SLiC part B ongoing

A	B	C	D	E	F	G	H	I	J	K	L	M	N	O	P
SLiC Part B Priorities	https://dcc.ligo.org/LIGO-T1600553														
Priority (partially assigned)	Issues	(Suspects) Causes	Related alog's (LHO)	Related alog's (LLO)	IJET	Chambers	Existing baffle / component	Existing Baffle use / for [ref LIGO-D1600493]	Notes	Proposed Upgrade	DCC	Cost Estimate	Cost per assembly	Status *NEW	
	ITM's and ETM's	ACB	41142			TMs			light reflection where axis of corner is normal to beam	After looking and realizing not as simple as replacing with simple baffle mounted to Quad, have option to replace box with new box made from BN or DLC coated panels.		\$30,000	\$2,500 x8. Includes new coated panels and re-coating existing close-by (glinting) sus parts (assumed BN). Plus machined parts to connect panels.	Moving to SLiC part C (FY19) as won't be ready to spend \$ b4.	
3	Reduction flange near ITM optical levers	Light that is not blocked by the baffle	41142			manifolds						\$5,000		Working now

1. SRM ghost beam baffle

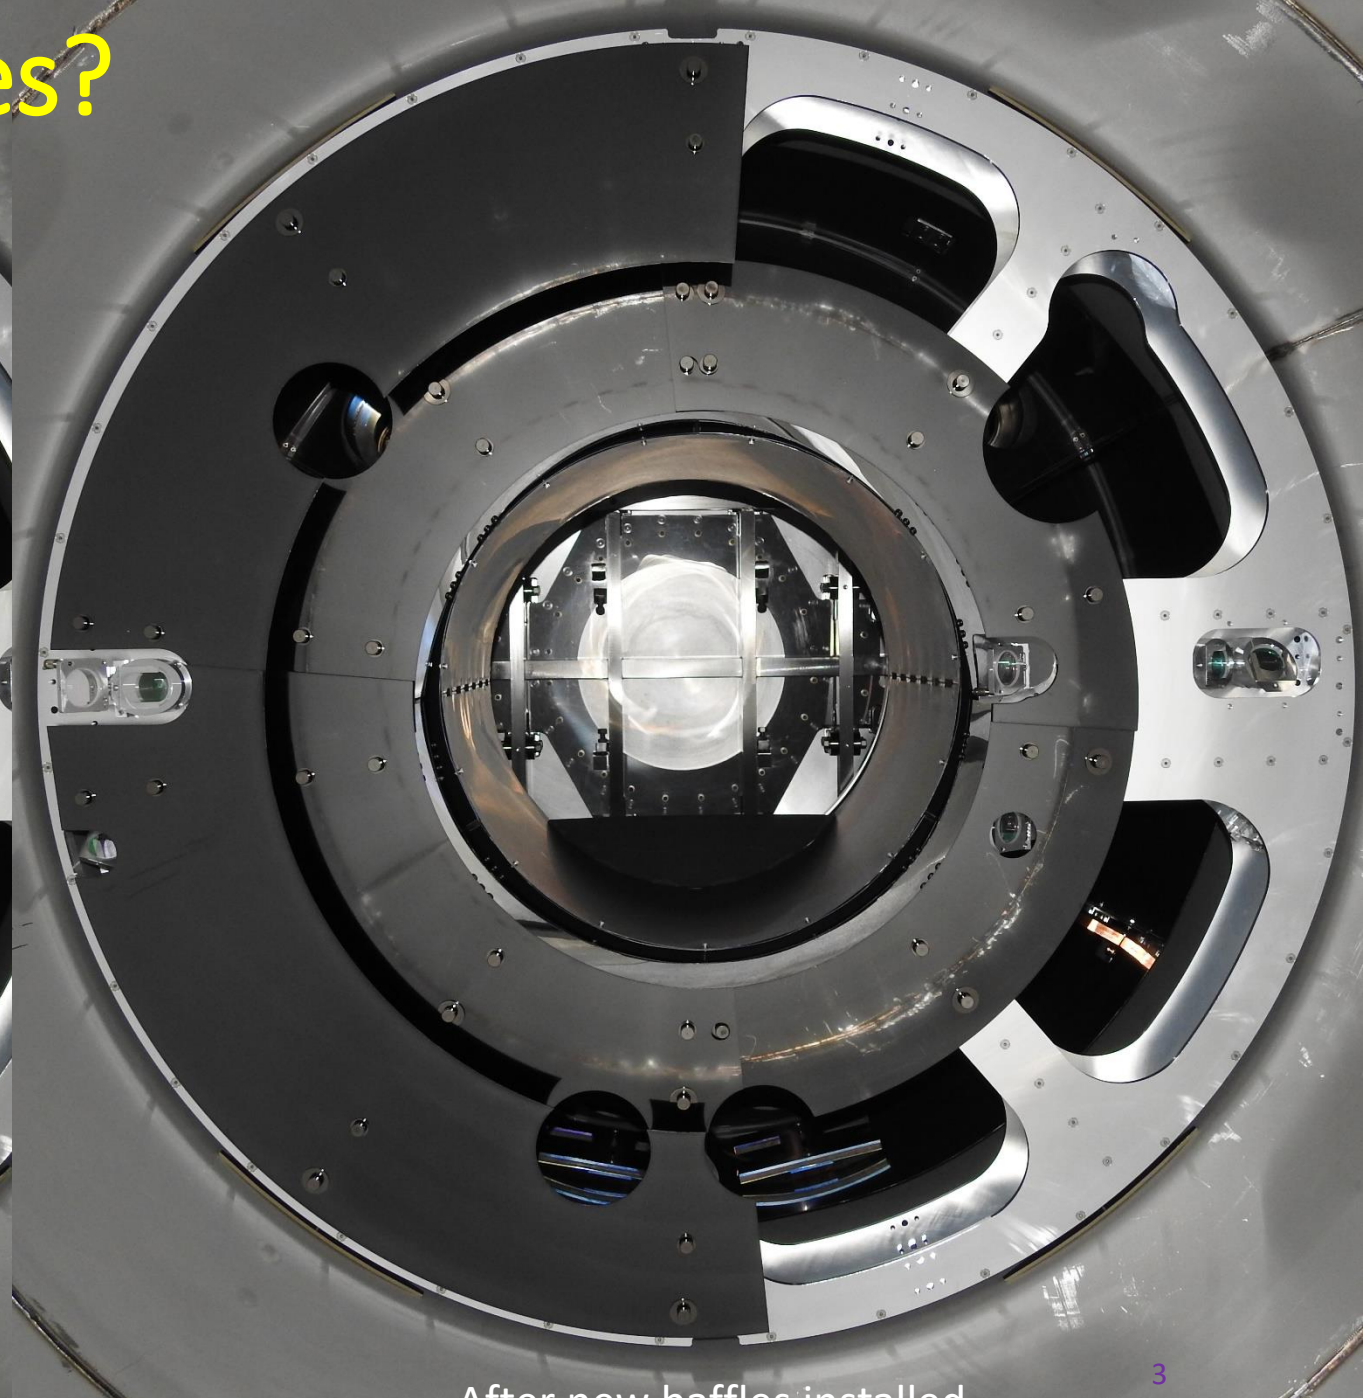
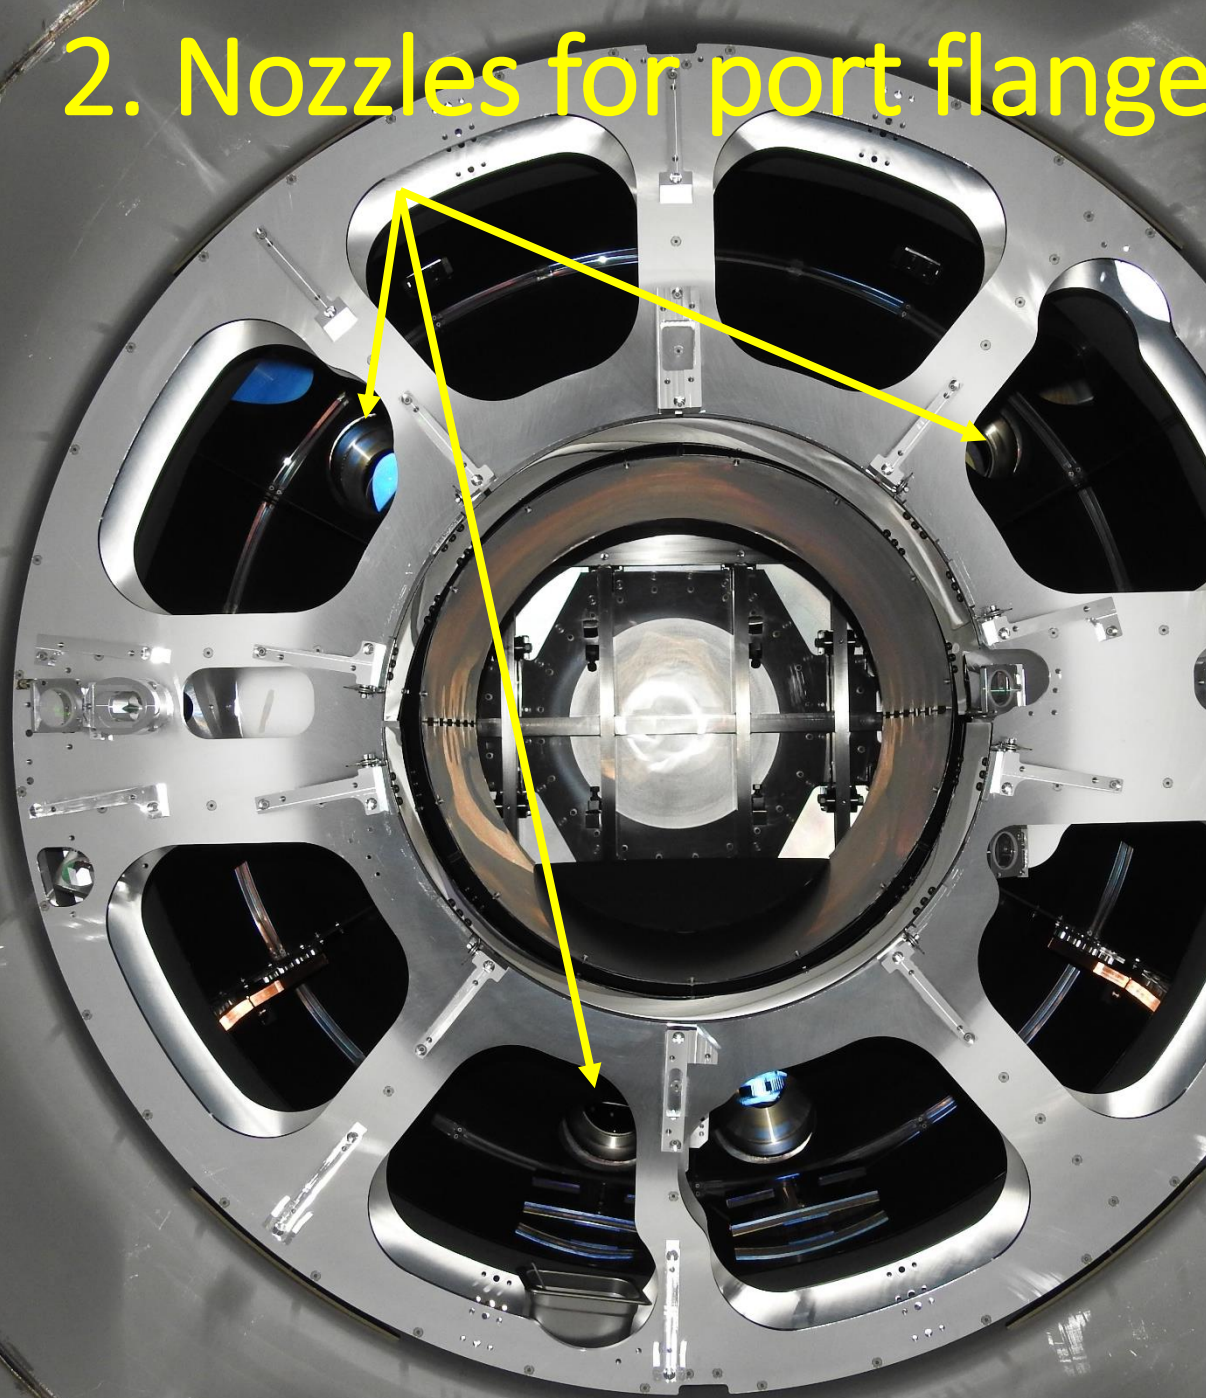
- pitched down
- AR coated glass maybe?
- How good do we know the ghost beam location?

3.Nozzles pcal

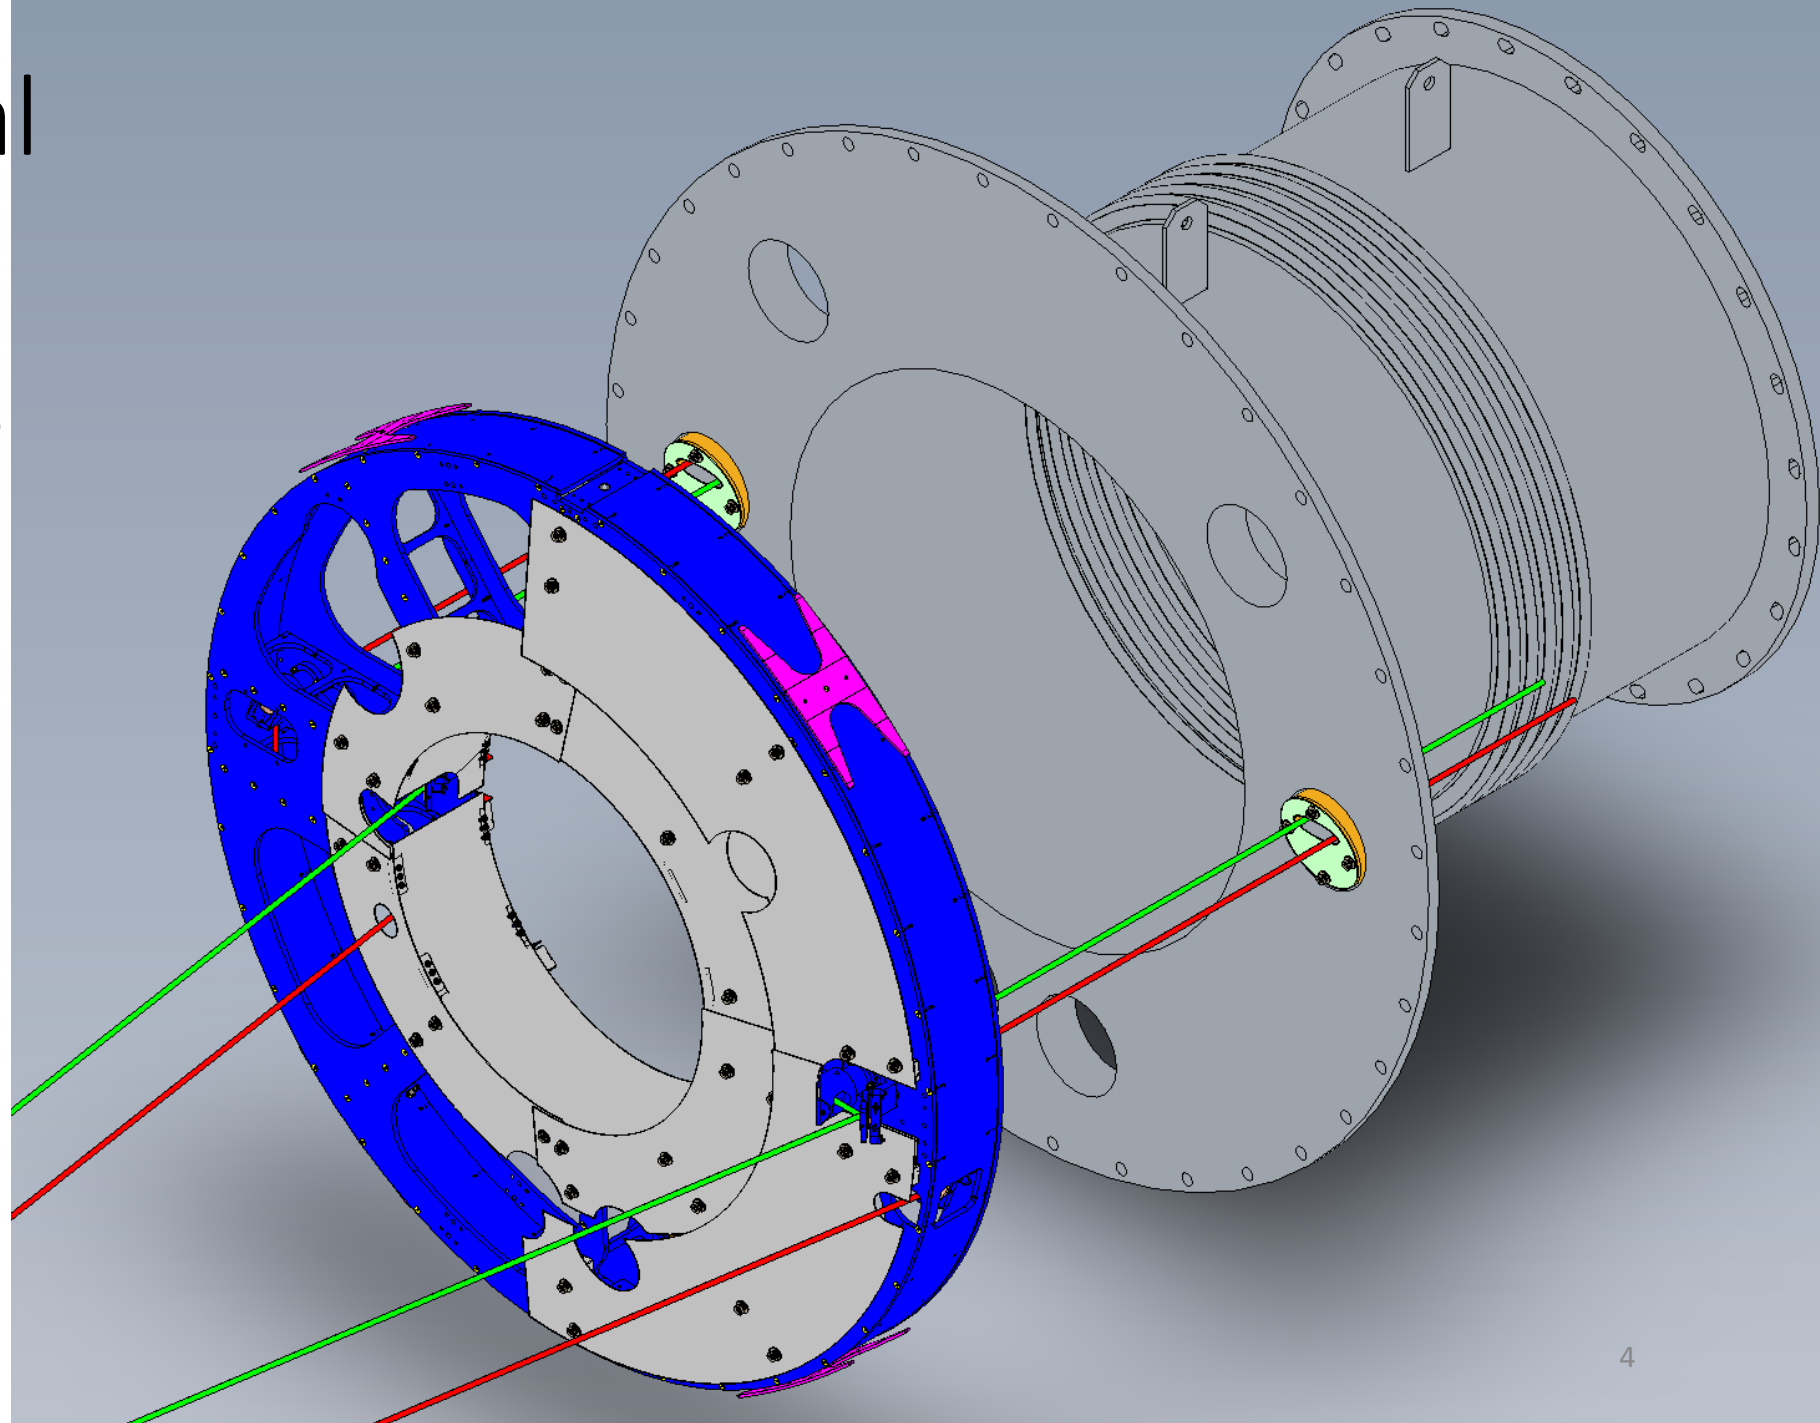
- pitched down
- will it fit through the VP?
- what VP to cover? Apertures?

3. Nozzles TCS CO2

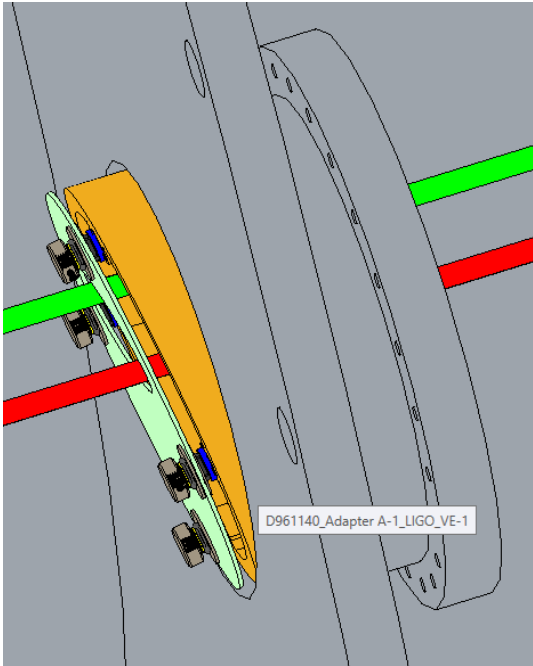
- pitched down
- mounts from the vacuum side
- aperture?
